Office Action Summary	Application No. 10/566,869	Applicant(s) NAGAI ET AL.	
	Examiner Thomas Diaz	Art Unit 4171

DETAILED ACTION

FIG. 1

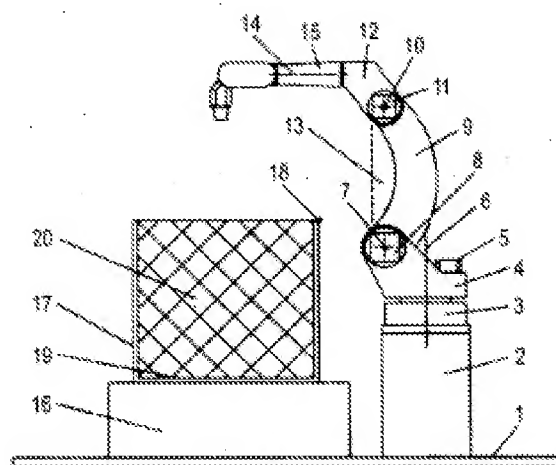
11. Applicant claims an industrial robotic arm as which is represented by Figure 1 below.

The applicant further claims that the first arm has a continuous-curved C shape, wherein the thickness of said C-shaped first arm decreases continuously from the swing part to a second arm drive part.

15. Regarding claims 3 and 4, applicant further claims that the center of gravity of the first arm is offset from the line connecting the rotating axes 8 and 10 due to said first arm having curvature as depicted in applicant's figure. Since the shape of the prior art structure is substantially the same as the applicant's embodiment shown by Figure 1, the center of gravity will be inherently offset as claimed.

FIG. 1

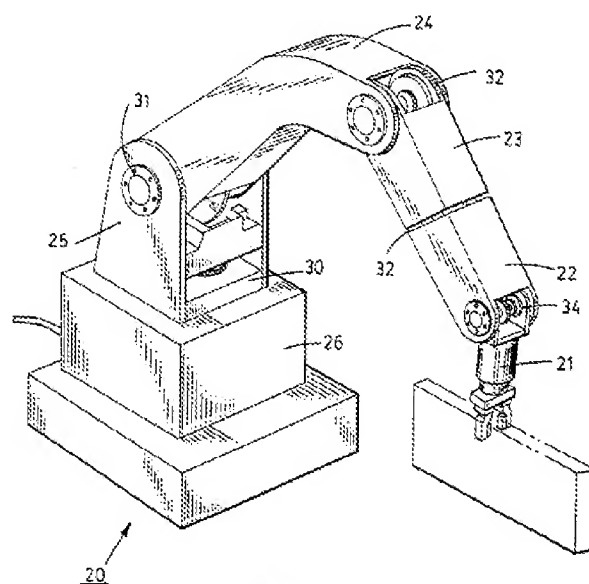
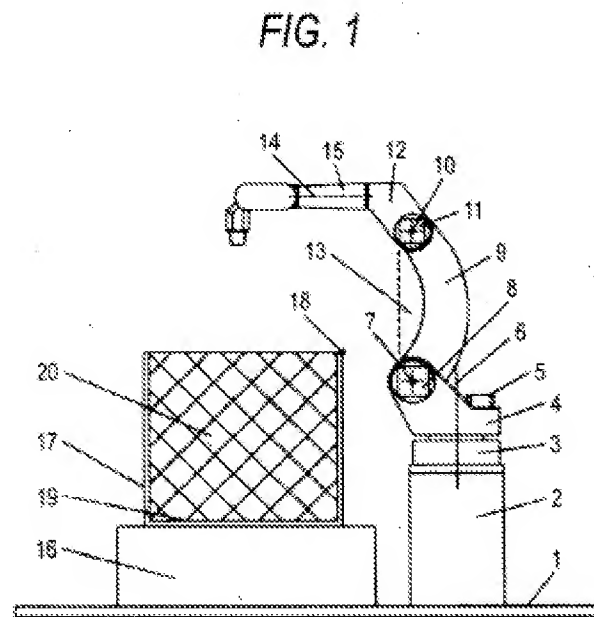
12. Huetsch teaches a robotic arm as shown below.

Claimed Limitations	Applicant's Ref. #	Huetsch's Ref. #
a base	3	26
a swing part	4	25
a first ("curved") arm	9	24
a second arm	12	23

As seen in the figure above, Huetsch teaches the first arm (fig.1, 24) having a continuously-curved C shape since it has a continuously-curved C shape portion (there is a c-shaped portion at the bend in the arm 24. There are two, in fact, one on the inner part of the arm 24, and another on the outer part of the arm 24). In addition the arm decreases continuously in thickness from the swing part (fig.1, 25) to a second arm drive part (fig.1, 32).

FIG. 2

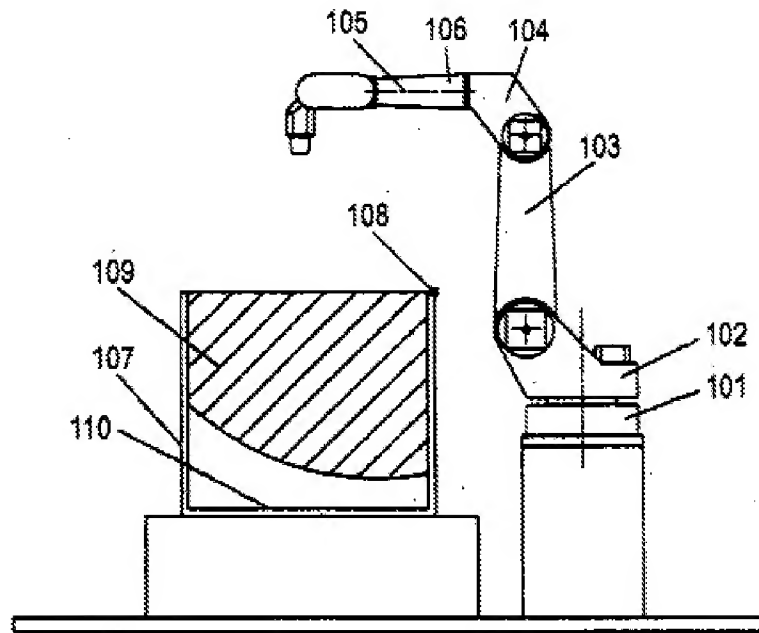
1. The drawings are objected to because figures 2 and 3 should be labeled with the label -prior art-. Examiner recommends changing the label from related art to prior art for consistency with the MPEP. Corrected drawing sheets in compliance with 37 CFR 1.121(d) are required in reply to the Office action to avoid abandonment of the application. Any amended replacement drawing sheet should include all of the figures appearing on the immediate prior version of the sheet, even if only one figure is being amended. The figure or figure number of an amended drawing should not be labeled as "amended." If a drawing figure is to be canceled, the appropriate figure must be removed from the replacement sheet, and where necessary, the remaining figures must be renumbered and appropriate changes made to the brief description of the several views of the drawings for consistency. Additional replacement sheets may be necessary to show the renumbering of the remaining figures. Each drawing sheet submitted after the filing date of an application must be labeled in the top margin as either "Replacement Sheet" or "New Sheet" pursuant to 37 CFR 1.121(d). If the changes are not accepted by the examiner, the applicant will be notified and informed of any required corrective action in the next Office action. The objection to the drawings will not be held in abeyance.

The APA teaches a similar industrial robot as seen in the figure below:

Above figure- APA robot.

The APA does not disclose the arm 103 having a continuous-curved C shape.

【図1】

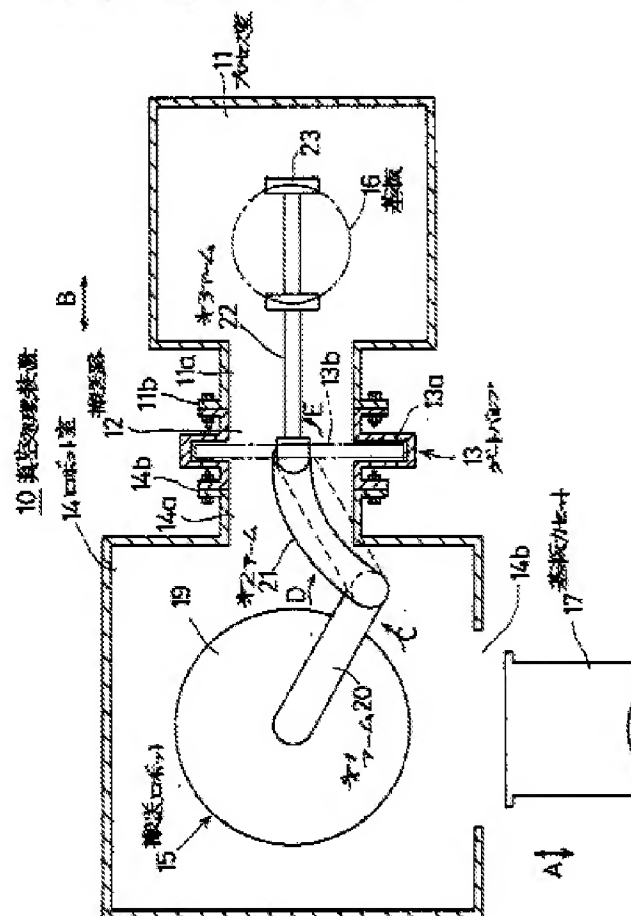
Nakamura teaches a robot having an arm which has a continuous-curved C shape (fig.1, 21) for the purpose of preventing interference with conveyance passage and also allows for a reduction in size of the work conveyance passage and reduction in the arm operation range (see abstract provided).

Therefore it would have been obvious to one of ordinary skill in the art at the time the invention was made to have employed the use of a c-shaped arm, as taught by Nakamura, in the device of the APA in order to provide for an arm that prevents interference with another object or work piece or casing.

Examiner notes that although Nakamura does not explicitly disclose a thickness of the arm decreasing from one end to the other end, it would be an obvious modification at the time of the invention to optimize the thickness of the arm in order to maximize the amount of interference prevented.

Above figure- Nakamura's robot.
